**Technical Service
Information Bulletin**

Title:
HEAT SHIELD RATTLE

Models:
'02 ES 300

NV001-02

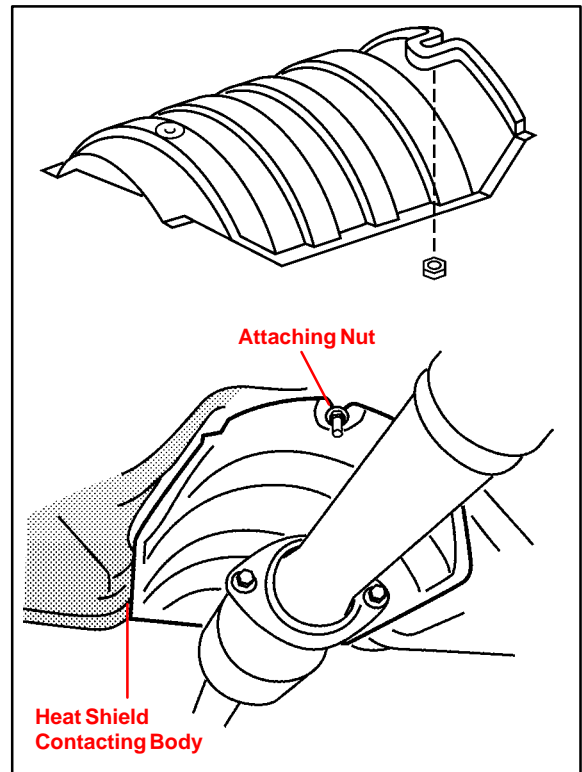
Introduction Under certain conditions, the heat shield for the catalytic converter on some 2002 model year ES 300 vehicles may be the source of a rattling sound. This rattle noise is most noticeable when driving at vehicle speeds above 50 mph, at which time, the air passing under the vehicle may cause the heat shield to vibrate and contact the body. As a result of this, the heat shield may generate a metallic rattle that sounds like it emanates from the dash or center console area.

1. While wearing work gloves, loosen the two nuts that attach the heat shield to the vehicle body.

2. Reposition the heat shield to center it, ensuring a minimum of 10 to 15 mm of clearance between both sides of the heat shield and the vehicle body.
3. If the heat shield is too wide to obtain the necessary clearances using the procedure in step 2, reposition both the left and right outer edges of the heat shield inward until the minimum clearance has been established.
4. Re-tighten the nuts securing the heat shield to the vehicle body.
5. Test drive the vehicle at speeds above 50 mph to verify the effectiveness of the repair.
